8-E-21-HZ
APPLICATION FOR CERTIFICATE OF APPROPRIATENESS

705 Deery St. 37902
Fourth and Gill H

Original Print Date: 8/9/2021
 Knoxville/Knox County Planning -- Historic Zoning Commission

Level III Construction of New Primary Building

REAR ELEVATION

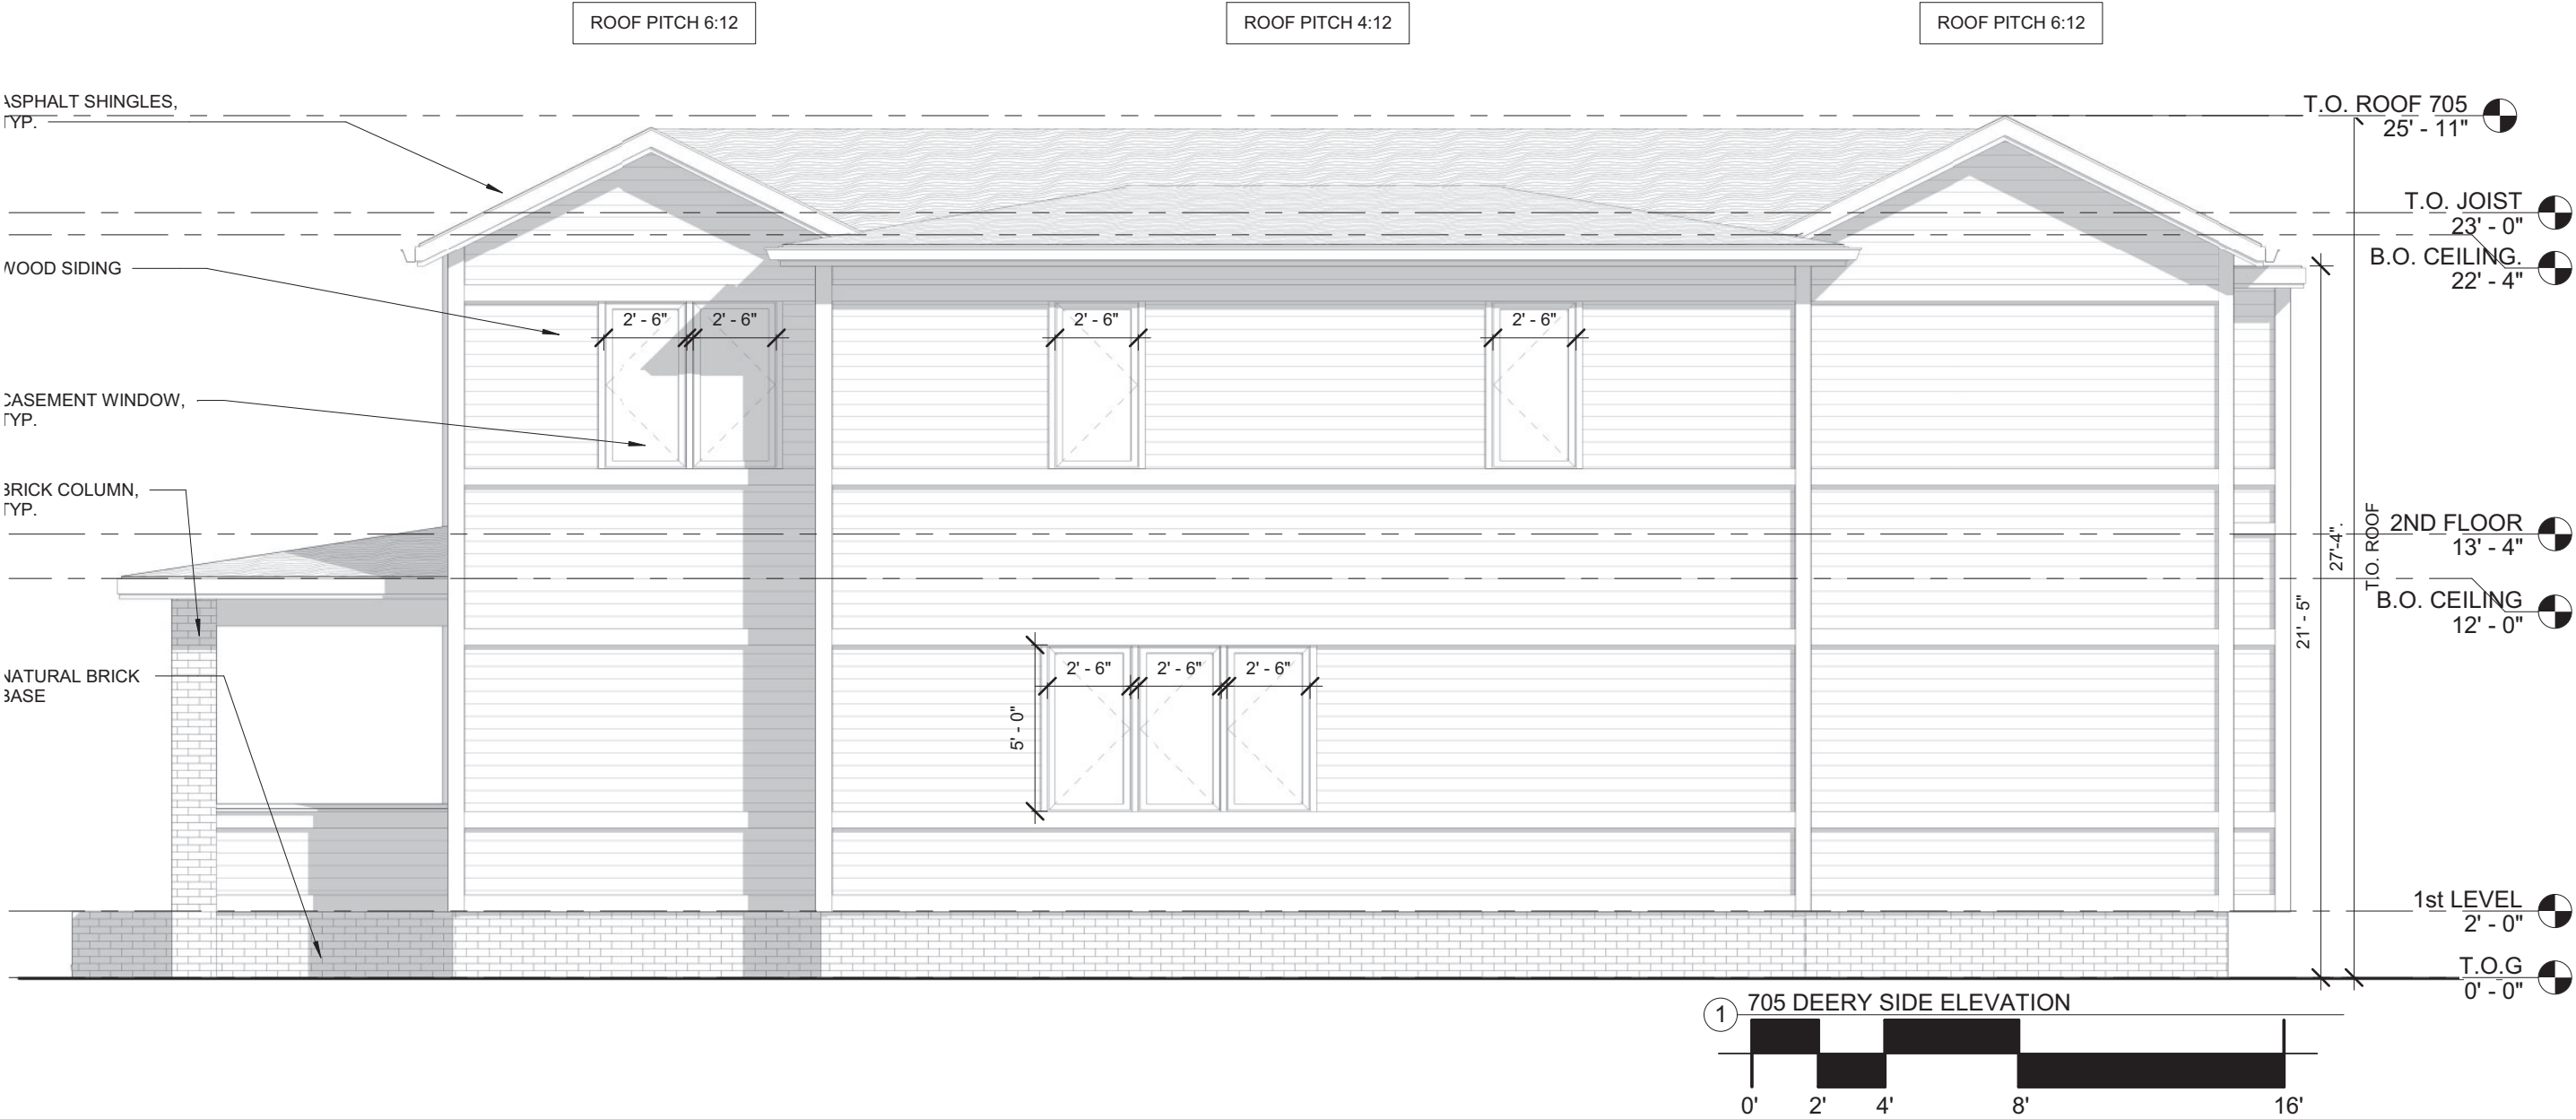
The flat-roof, two-story projecting massing on the rear elevation is a unique tactic to incorporate additional interior space. It will be somewhat visible from the street due to the size of the proposed house. It does contribute transparency to the rear elevations.
